Portishead Branch Line (MetroWest Phase 1)

5.6, Flood Risk Assessment, Part 17 of 17

Appendices P to T

MetroWest Phase 1, Flood Risk Assessment: Consultation meeting with EA

TITLE
UTILITIES INFORMATION
DROVE RHYNE
SHEET 1 of 1

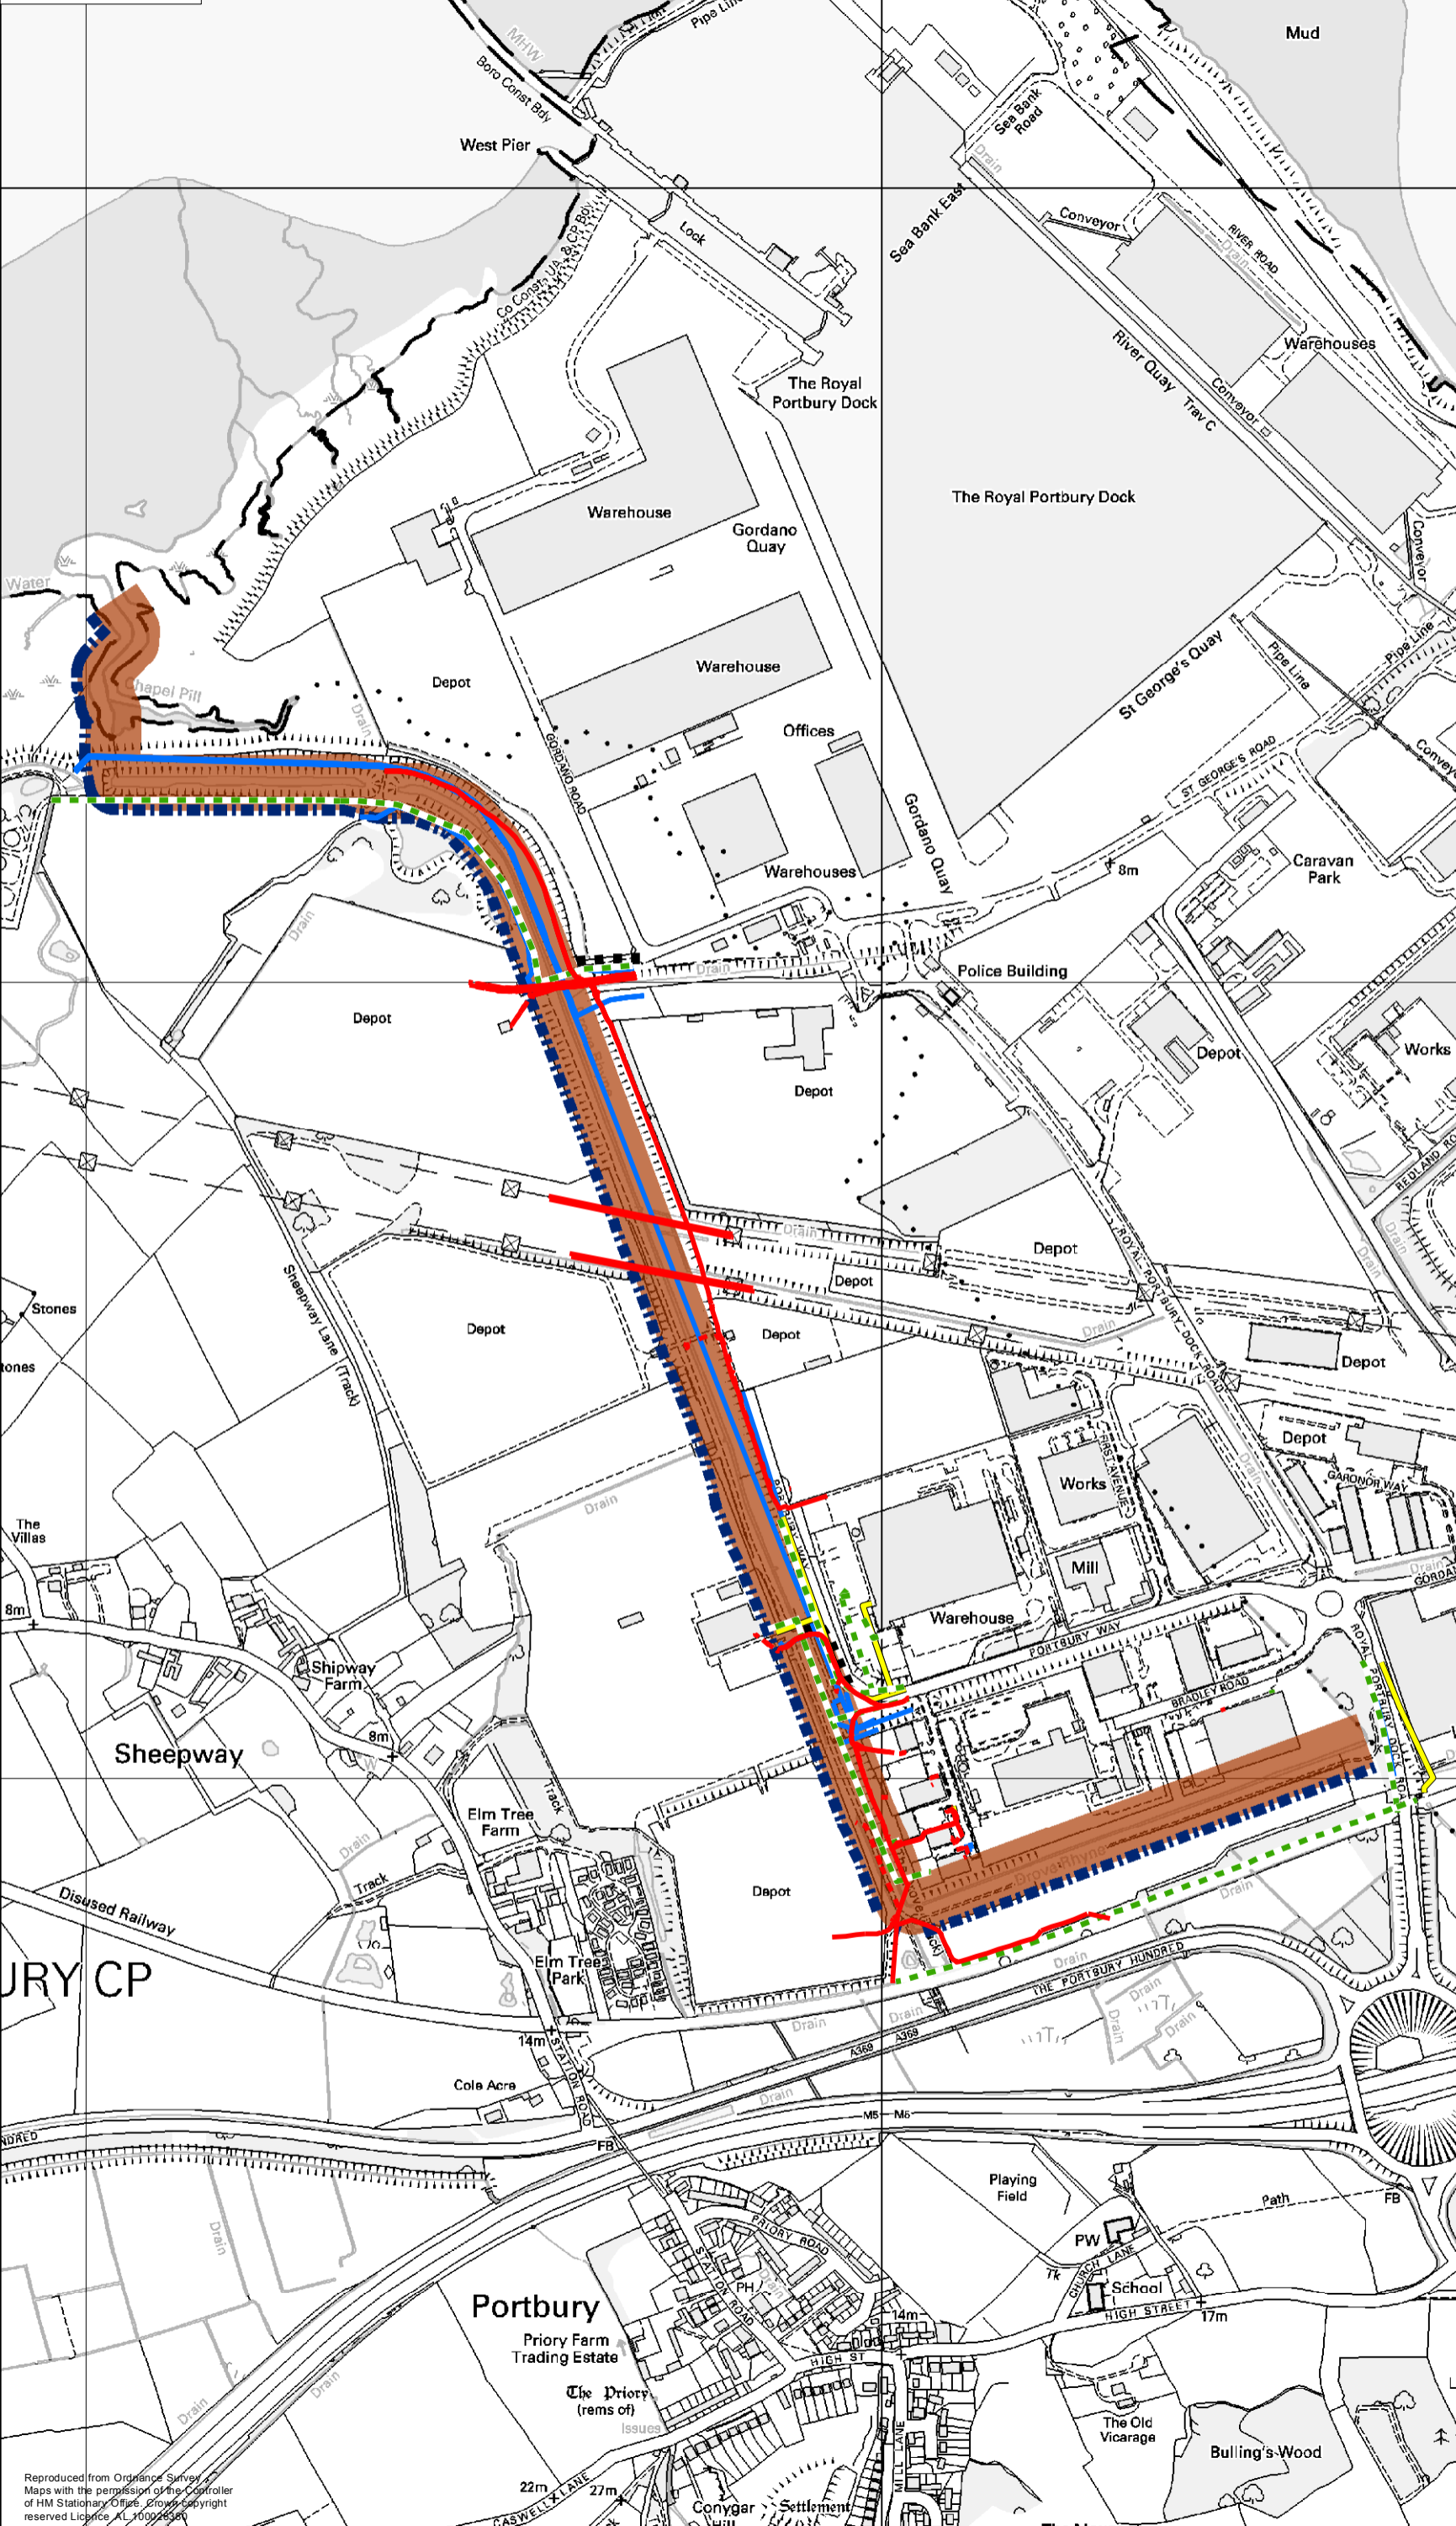
Please find attached a plan that shows our current access route along the Drove Rhyne for weed cutting along the left bank. Our future access to the inland bund via the B3124 is to the left of Sheepway Gate Farm.

Portishead - Discharge Consents and Outlets

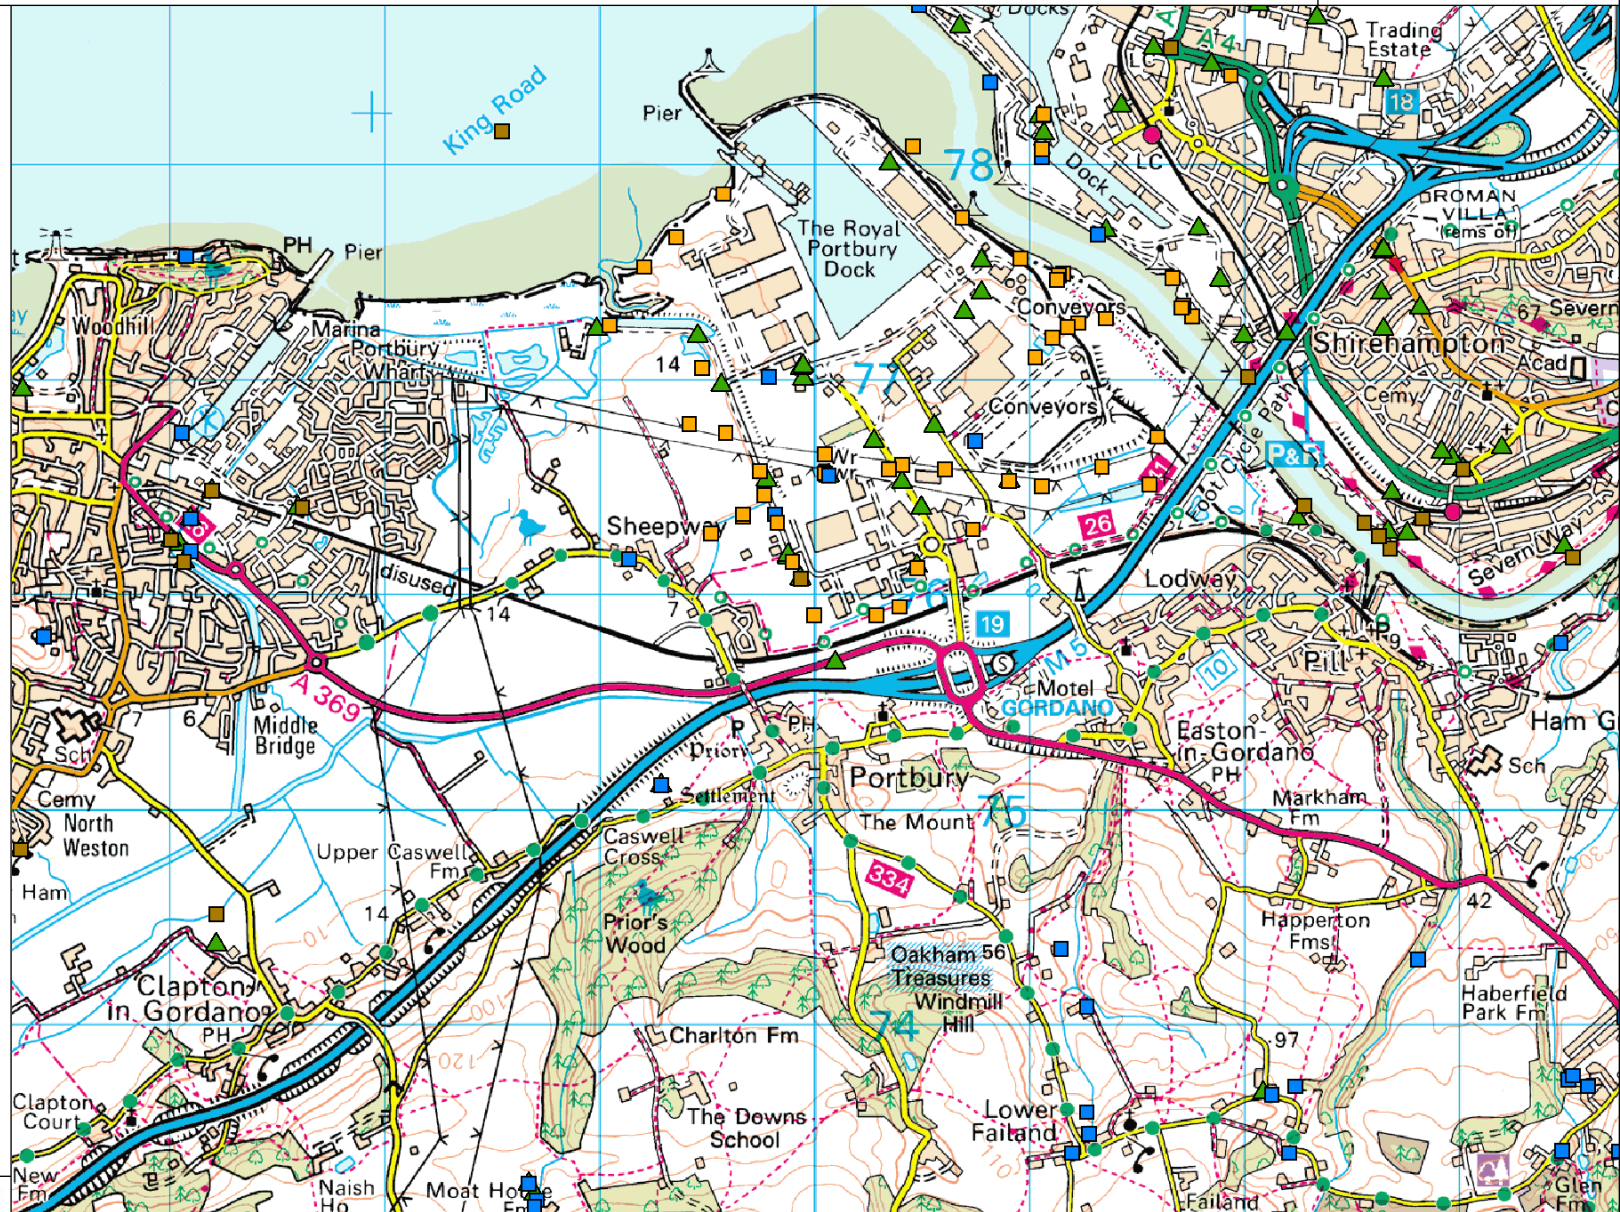
As requested, please find attached a plan indicating the position of all known discharge consents and their associated outlets in the area.

Drawing: FIGURE 2.2: PORTISHEAD TO PILL DCO APPLICATION SITE & ENVIRONMENTAL CONSTRAINTS 1 of 8

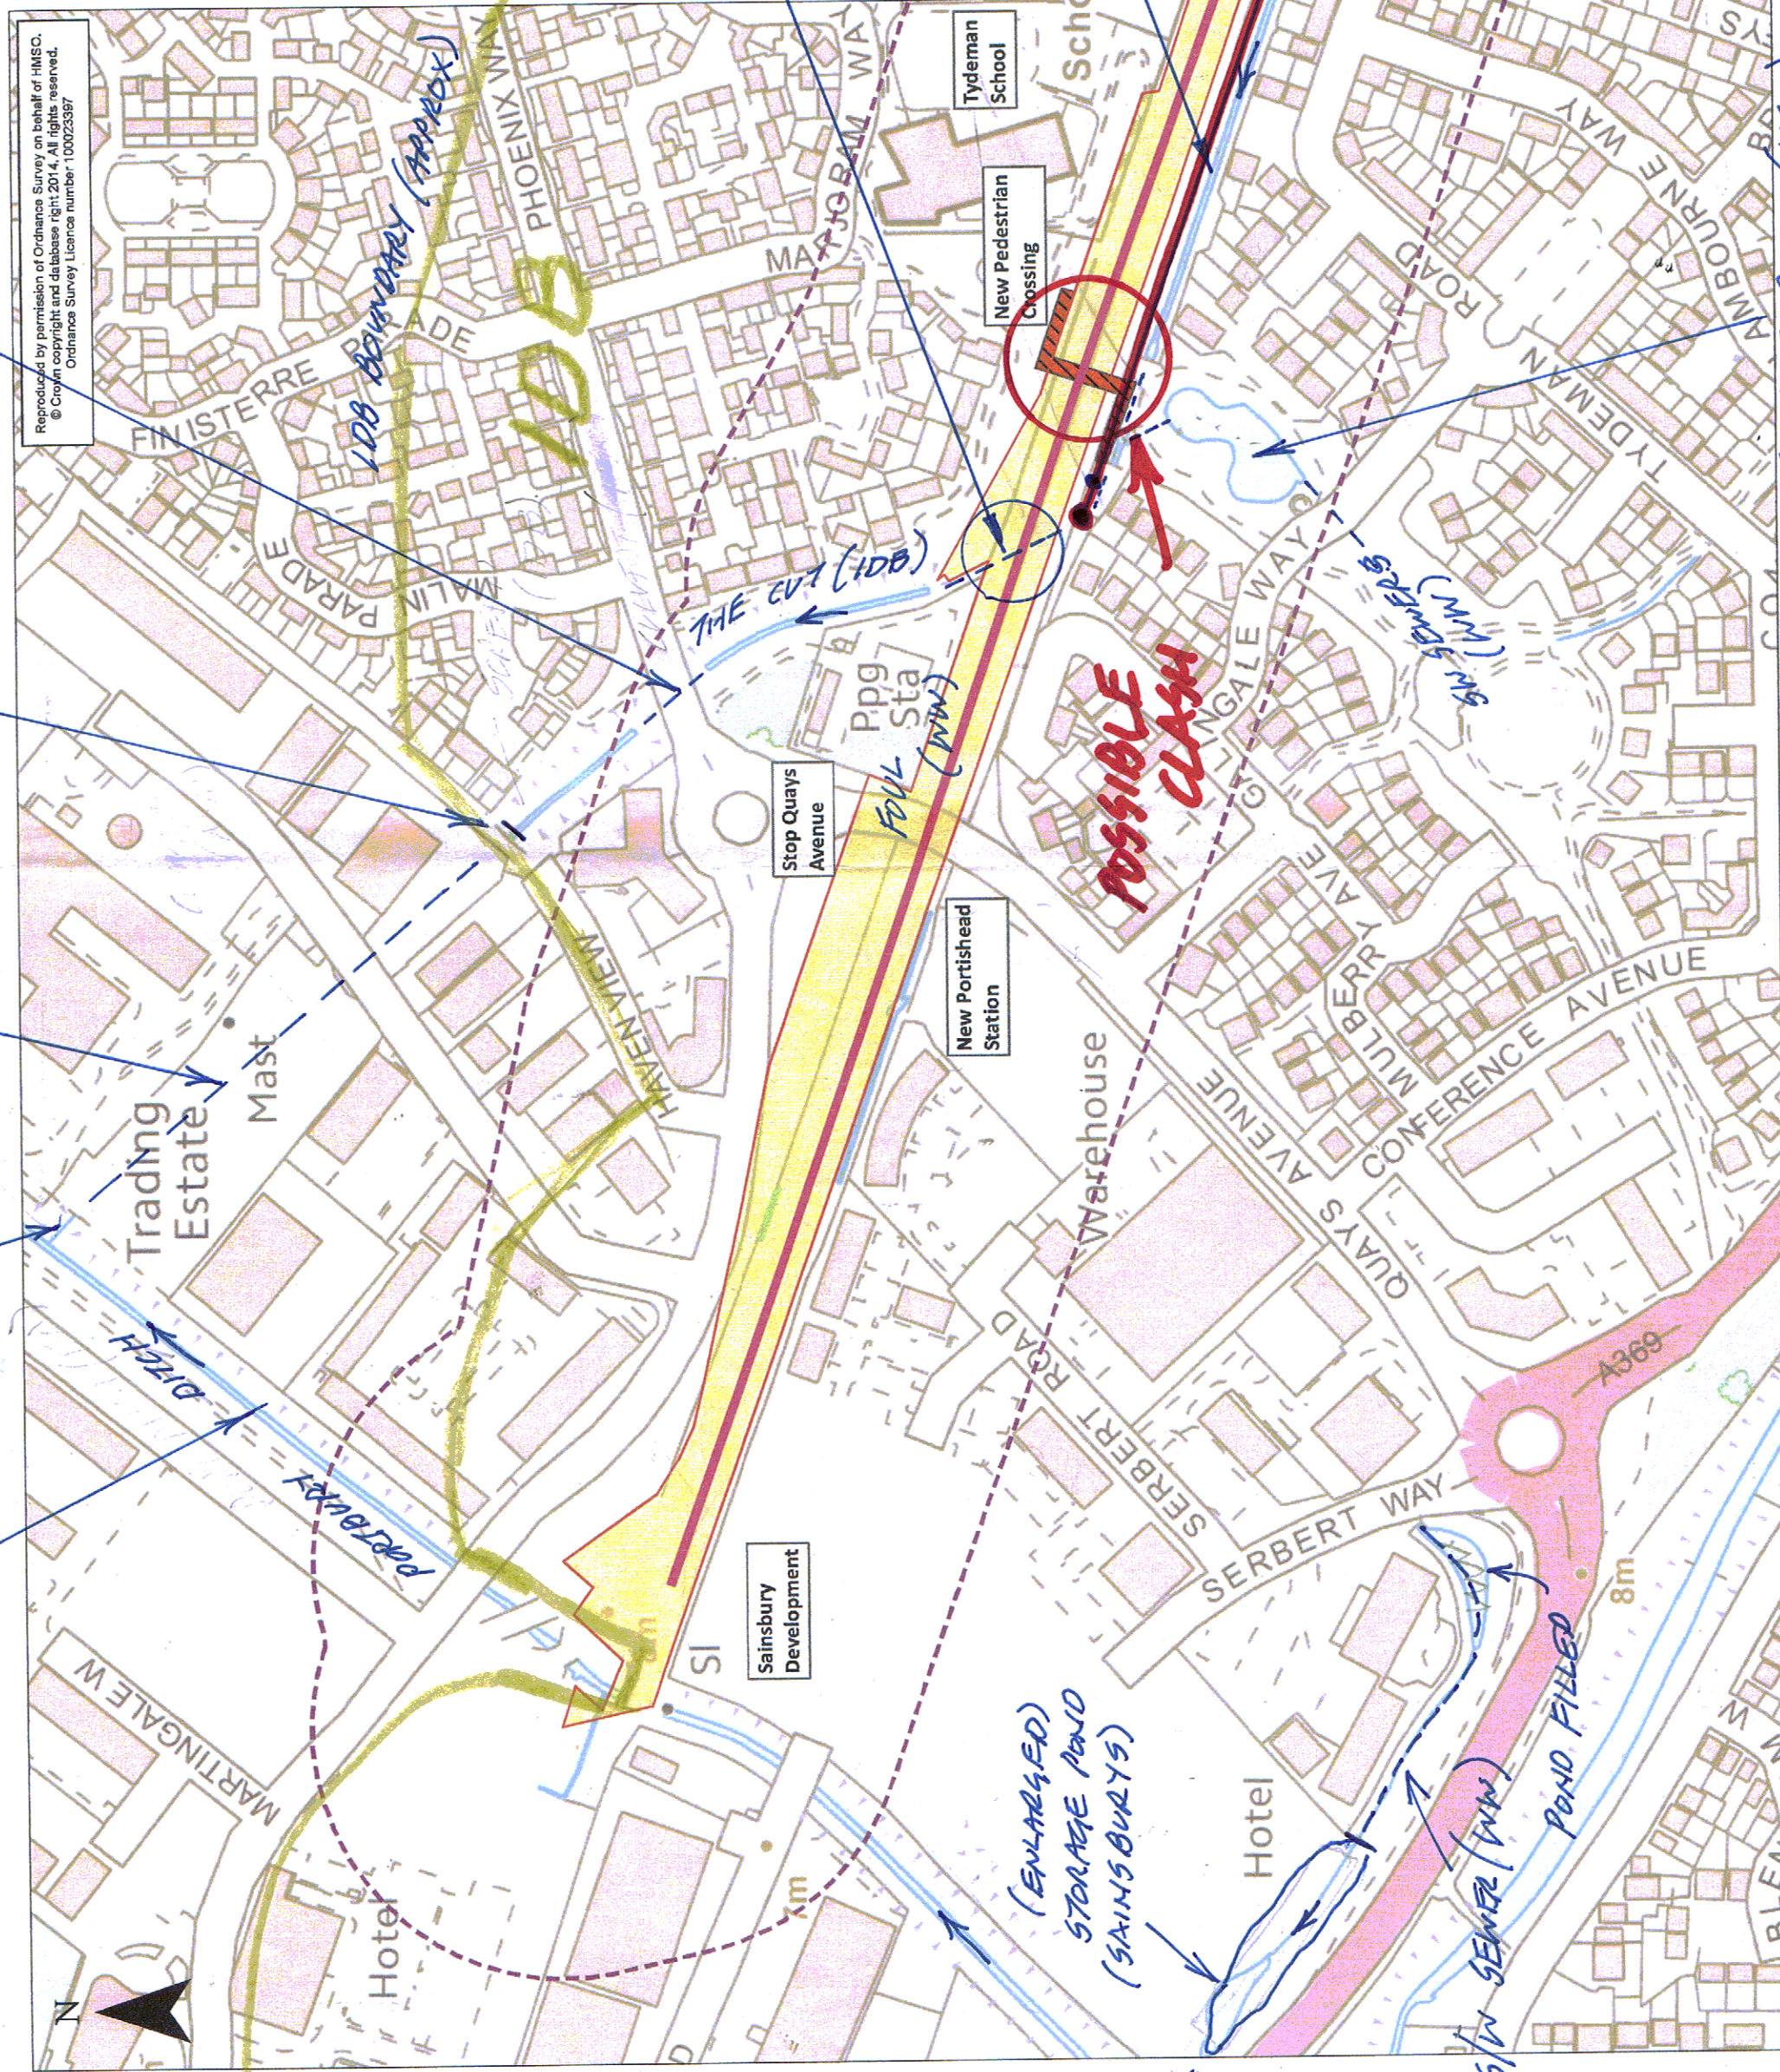
On sheet 1 you will see have identified a potential clash. The watercourse which runs parallel to and south of the railway is an important local drain and is routinely cleaned out by the IDB using mechanised plant . The Board's access route is marked in red so the bridge would need to clear this. At present it would also be impossible to form a footpath from the bridge towards the station because just upstream of the culvert under the railway the gap between the housing and the watercourse is very narrow. However both issues could be solved by extending the railway culvert all the way to a point East of the footbridge.
